## Dual IHR Hose Tracking Improvement Field Kit

Kit Part Number: 261625

**TECHNICAL BULLETIN 262007**

**Figure 2**

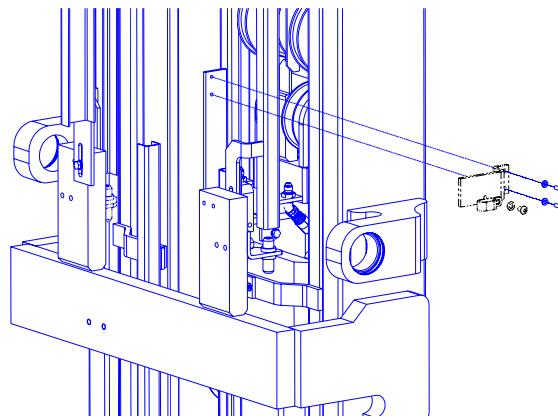
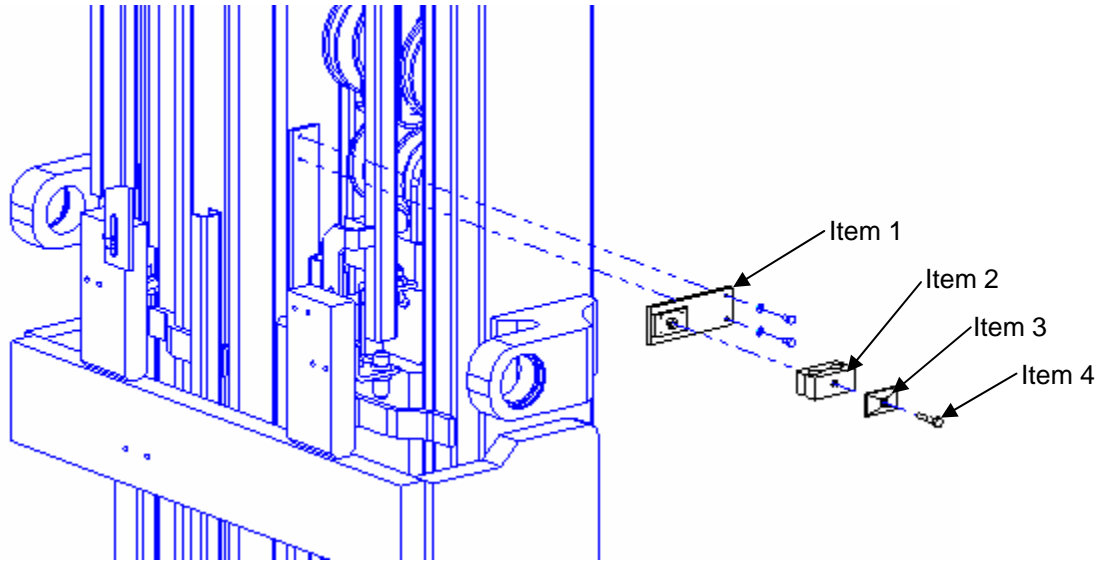
1. Replace existing bracket, hose clamp, flat washer, and capscrew (see Figure 1) with updated bracket, clamp, cover plate, and bolt (items 1, 2, 3, & 4) shown in Figure 2. Clamp (item 2) should be aligned with pad on bracket (item 1) before tightening cover plate and bolts (items 3 & 4). M6 hardware for mounting bracket is to be reused and should be torqued to 8Nm (71 in-lbs).

**Figure 3**

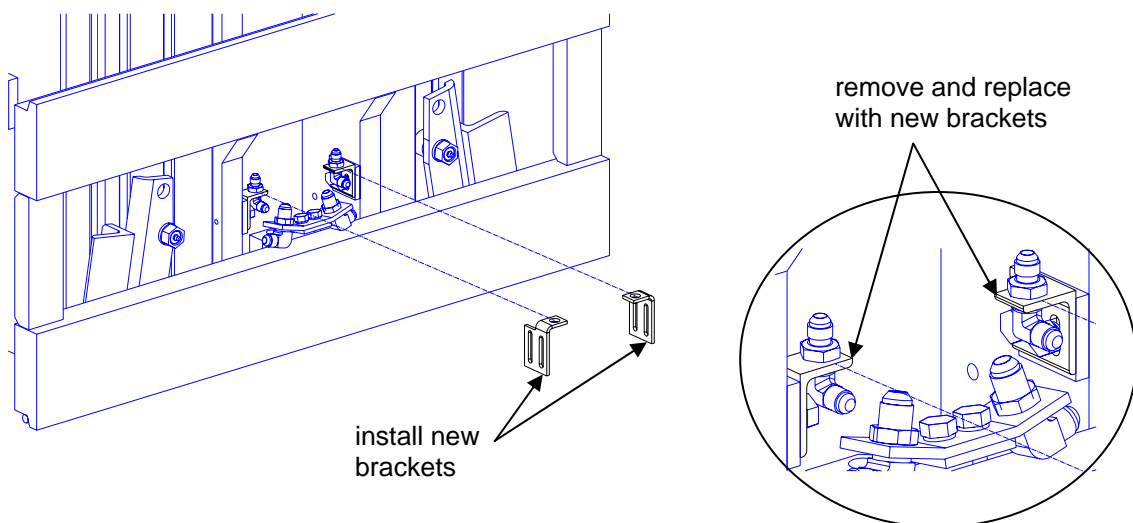
2. Replace existing brackets holding #6 90° hose fittings to carriage assembly with new brackets (items 5 and 6) with longer adjustment slots (see Figure 3). M8 hardware for mounting bracket to be torqued to 20Nm (177 in-lbs).
